GLEN INNES WIND FARM RESPONSE TO SUBMISSIONS MODIFICATION 4: TURBINE DESIGN CHANGES

*Prepared for Glen Innes Windpower Pty Ltd
Prepared by Environmental Property Services*

Figure 1 GIWF Approved Mod-2 and proposed Mod-4 layout (amended for Response to Submissions)

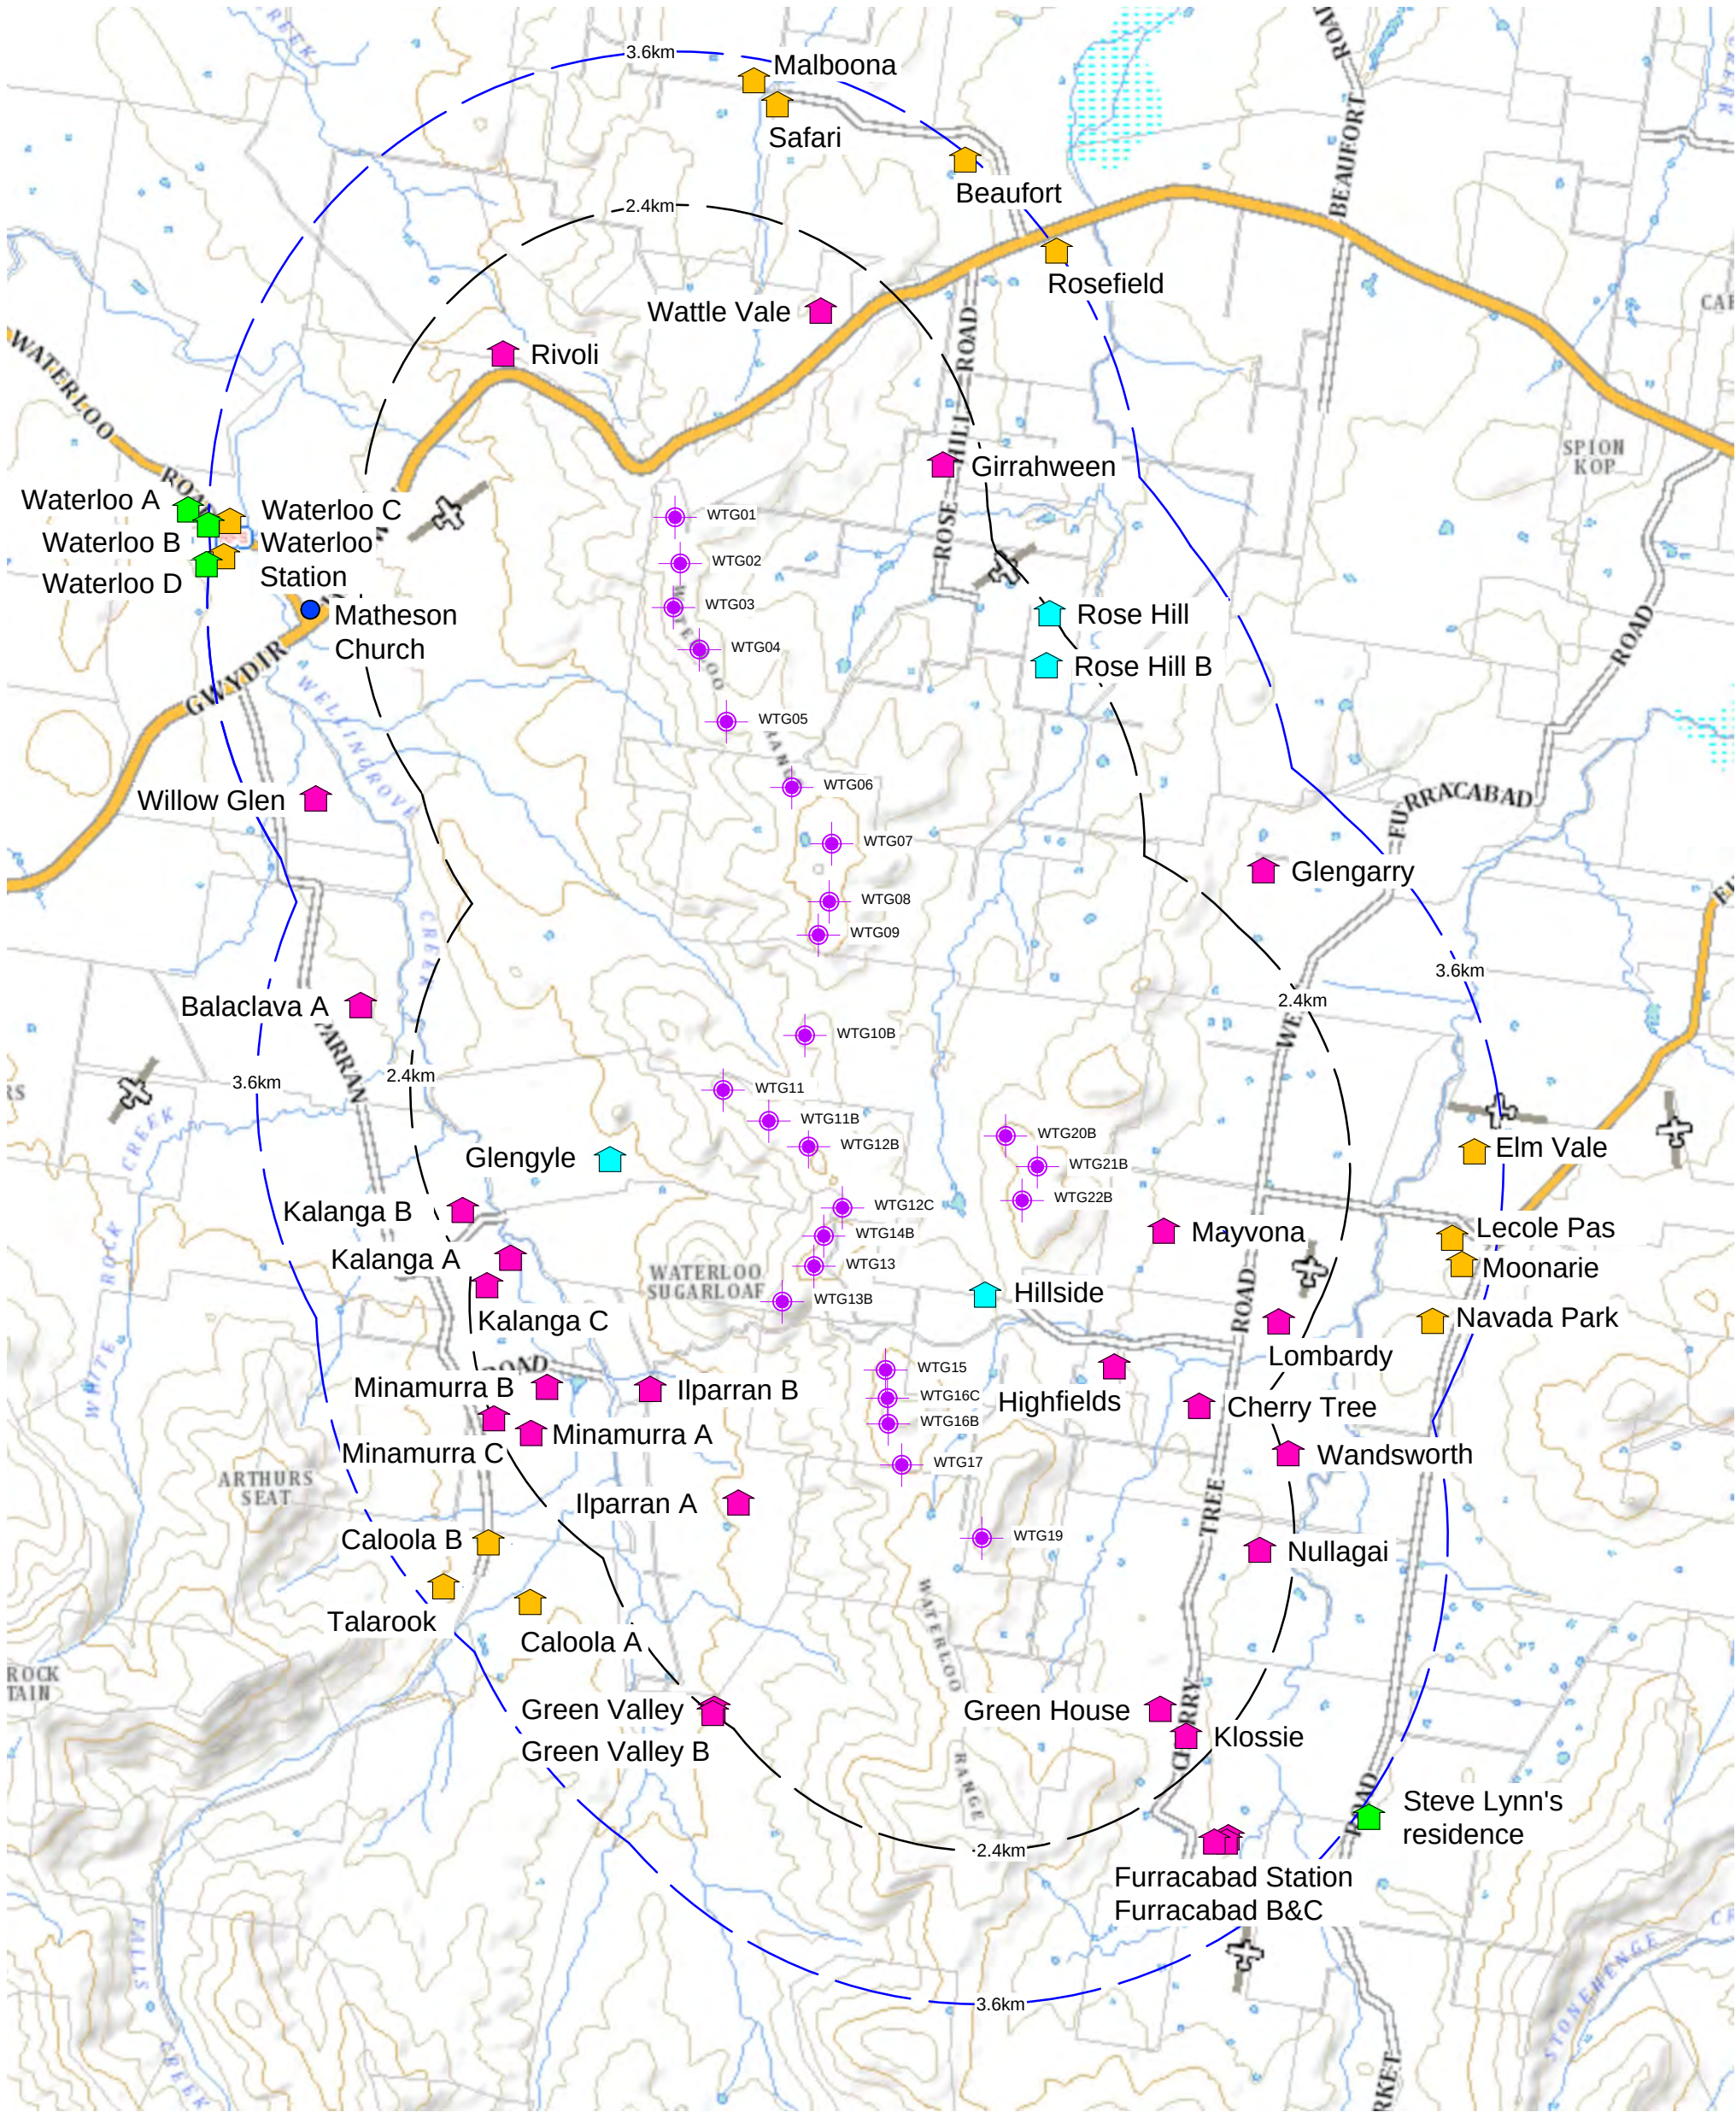
Figure 5-1 shows the various viewpoints around the Glen Innes Windfarm, including the residences within 3.6 km in accordance with the New South Wales State Government Wind Energy: Visual Assessment Bulletin December 2016. Figure 5 of this Bulletin provides a visual magnitude threshold for visual assessment based on turbine height and distance from dwellings. For the proposed 180 m tip height, the threshold distance is 3.6 km.

Figure 5-1 includes the 6 additional residential dwellings identified in submission including those described as being occupied full time, as well as the Matheson Church.

Waterloo Station main house, which is approximately 3.5 km from the nearest approved (or proposed) turbine and is indicated at this distance in Figure 5-1. Figures 2 and 3 of the Visual Impact Assessment compared the zones of visual influence as approved and as proposed and showed that Waterloo Station remains within the same zone of visual influence. The Visual Impact Assessment classified Waterloo Station with a Level 1 sensitivity rating based on its local heritage listing. Figure 5-2 is a new wireframe model for Waterloo Station main house and shows that views south east toward the approved GIWF Mod-2 (and proposed Mod-4) wind turbines are generally open and extend to wind turbines around 7 kilometres from the dwelling. The house has a high visual impact rating for both the approved and proposed turbine designs. The Mod 4 wind turbines would not result in any significant increase in visual effect associated with the approved wind turbines.
